UNITED STATES PATENT AND TRADEMARK OFFICE

10/530,634

Office Action Summary

DETAILED ACTION

**FIG. 13**

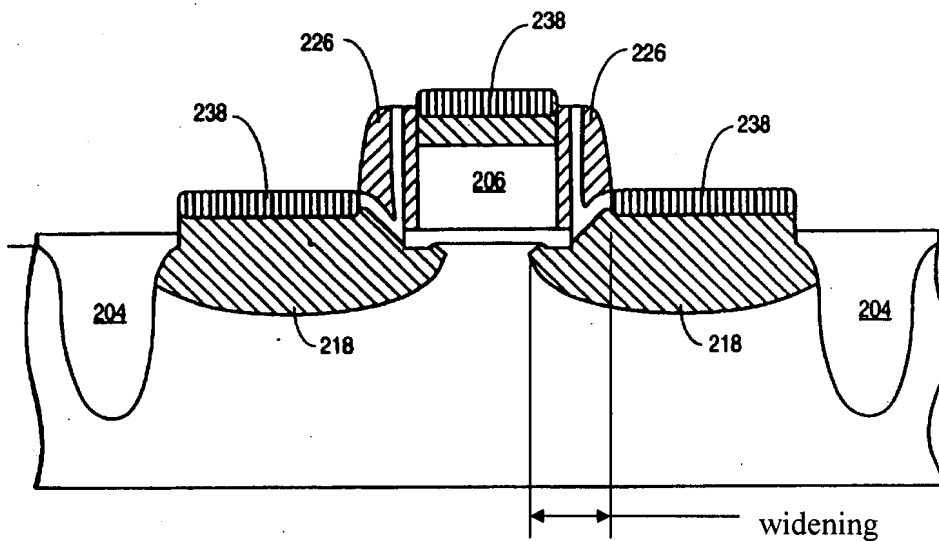
With respect to claim 22, Roberds discloses the field-effect transistor as claimed in claim 2. Roberds (Figs. 1-6) discloses a gate insulation layer [22] is formed at sidewalls of the gate layer. Roberds does not specify that a spacer [26] is located laterally between the gate insulation layer and the depression sidewall insulation layer. However, Murthy et al. (Fig. 6) discloses that it is well known for a spacer [see figure below] to be located laterally between the gate insulation layer [see figure below] and the depression sidewall insulation layer [38]. It is well known for a spacer to be located laterally between the gate insulation layer and the depression sidewall insulation layer in order to further protect the gate electrode. Therefore, it would have been obvious to one of ordinary skill in the art at the time the invention was made for the device of Roberds to have a spacer located laterally between the gate insulation layer and the depression

With respect to claim 24, Roberds discloses the field-effect transistor as claimed in claim 2. Roberds does not disclose that a spacer extends into the widening. Murthy (Figs. 2, 8-14) discloses that it is well known for a field-effect transistor to comprise a spacer [213] that extends

into the widening [244]. Murthy teaches that it is beneficial for a spacer to extend into the widening in order to further reduce the distance between the gate electrode and the electrically conductive filling layer, which would reduce an adverse capacitance [paragraph 0030].

Therefore, it would have been obvious to one of ordinary skill in the art at the time the invention was made for a spacer to extend into the widening in order to further reduce the distance between the gate electrode and the electrically conductive filling layer which would reduce an adverse capacitance.
